Access Compliance Report

Public Rights-of-Way

| Intersection ID: 2874 | Main Street: HORNBEAM_CT | Cross Street: LADY_BANK_DR | Location: SE |
| ADA ID: 5D38D1FA26C7 | Ramp Type: Perp | Initial Pass/Fail: Fail | Overall Compliance: No |

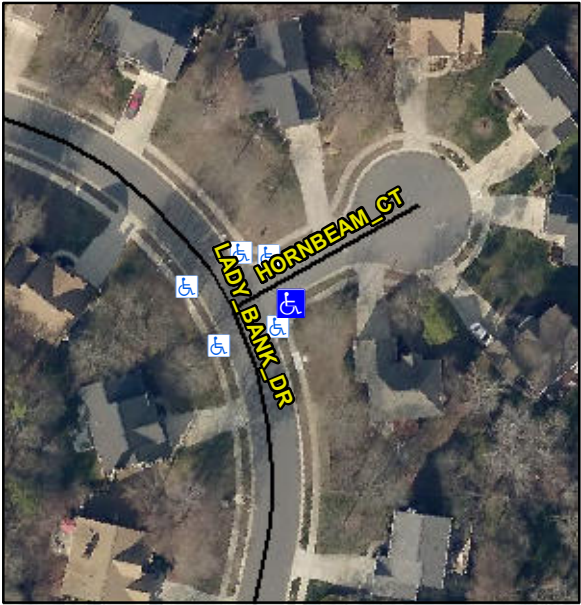
| Codes/Mitigation Info/Possible Solution | | | Field Measurements/Component Compliance | | |
|--|--|--|---|-----------------------------|-------------|
| | Remove & Replace Entire Ramp. | | No | Ramp Length (in) | 49.0 |
| | | | No | Ramp Width (in) | 40.0 |
| <p>Surveyor Notes:</p> <p>N/A</p> <p>PROW/ADA:</p> <p>R304.5.1, R304.2.2, R304.5.3</p> | | | N/A | Flare Type RT | N/A |
